PRODUCT AFFECTED

OB-SX

DESCRIPTION OF CHANGE

"OCT. 1981 UPGRADE OF OB-SX"

DRAWING N° 1469 SHEET 5 OF 5

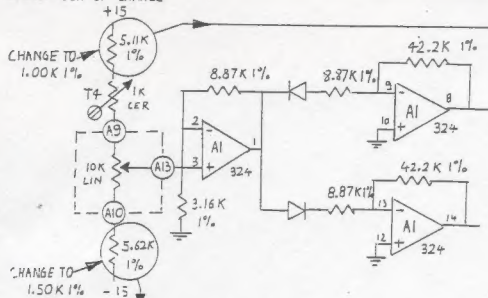
TO INCREASE THE RANGE OF THE "CENTER LEVER" TRIMMER T4

VOICE CARD N^o 1460

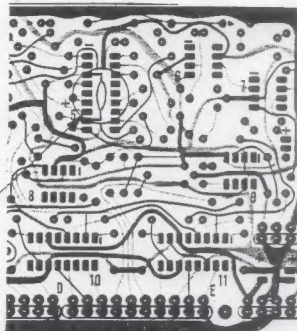
ADD A .001μF
BETWEEN PIN 8 AND PIN 3 OF A5

- REMOVE OSCILLATION

1469 Sheet 5 of 5

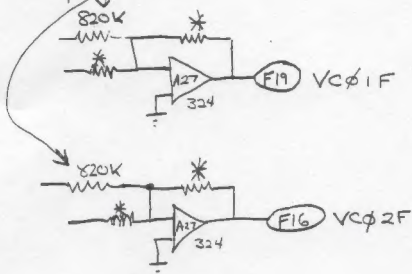
Replace 2 820K 5% resistors to 806K 1% on
Control Board

these are changed

to Match the LFO gain between VCO's
